## **SERVICE BULLETIN ASM-008**

**Product: Antenna System Monitor**

**Subject: Firmware 2.20 Release**

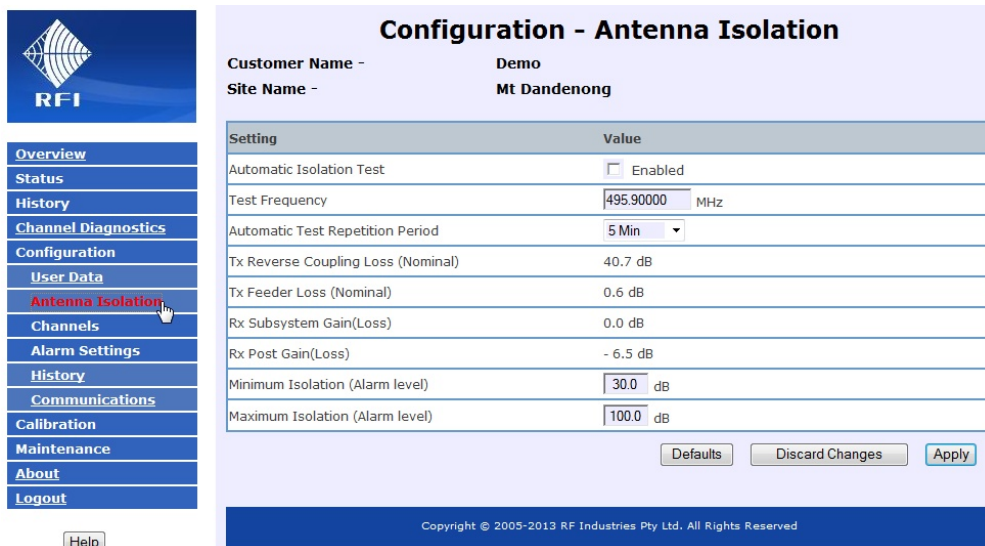
- iii) An improved algorithm is now implemented for measuring Tx Power and Rx Level. This new algorithm improves ASM measurement accuracy across all selections of modulation type and channel bandwidths – and combinations thereof. As a result, on some units' configuration, a value adjustment may be required for the Forward Coupling and Reverse Coupling values on the *Configuration – Tx Port* pages of the GUI.

This may be most easily adjusted in value if the Tx Output power on the output of the Tx combiner is known for any monitored frequency (this can also be calculated from the Tx combiner test results if they are available). Prior to upgrading the ASM to this version 2.2 firmware, record the Last Recorded Tx Forward power for all channels on the *Status – Tx Port* pages of the GUI.

After performing the version 2.2 firmware upgrade, adjust the Forward Coupling value until previously recorded Tx Fwd Power levels are again displayed for a channel on the *Status – Tx Port* pages.

Once this revised Forward Coupling value has been determined, adjust the corresponding Reverse Coupling value and then all other Forward Coupling and Reverse Coupling values on the other *Configuration – Tx Port* pages of the GUI by the same adjustment amount (i.e. 0.7dB).

At the next opportunity (i.e. the next PMI site visit), repeat the normal Calibration process to confirm these new coupling values are optimised.

### viii) Rx Level Display in Status - Antenna Isolation screen

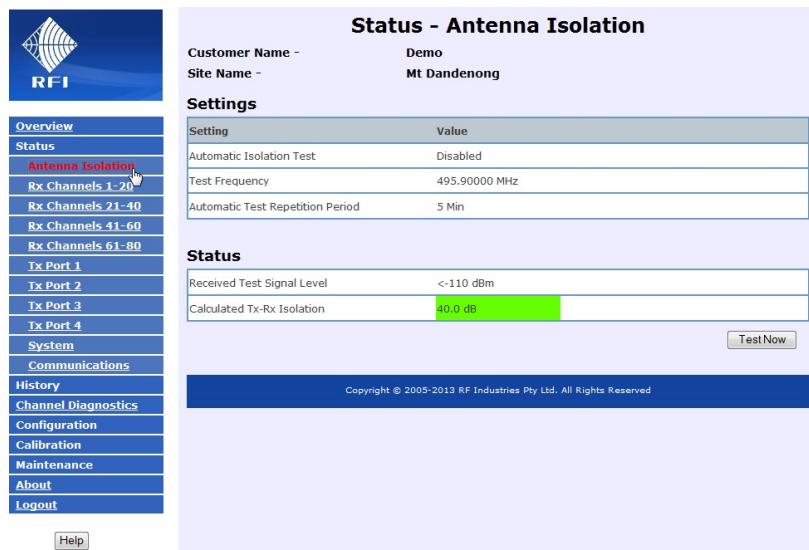
This feature adds a maximum alarm threshold to the existing minimum threshold, allowing various fault conditions including the loss or failure of the system Rx antenna or TTA/RMC to be detected and reported.

Displaying the Received Test Signal Level shows the measured Rx Level value as measured in the Antenna Isolation test.
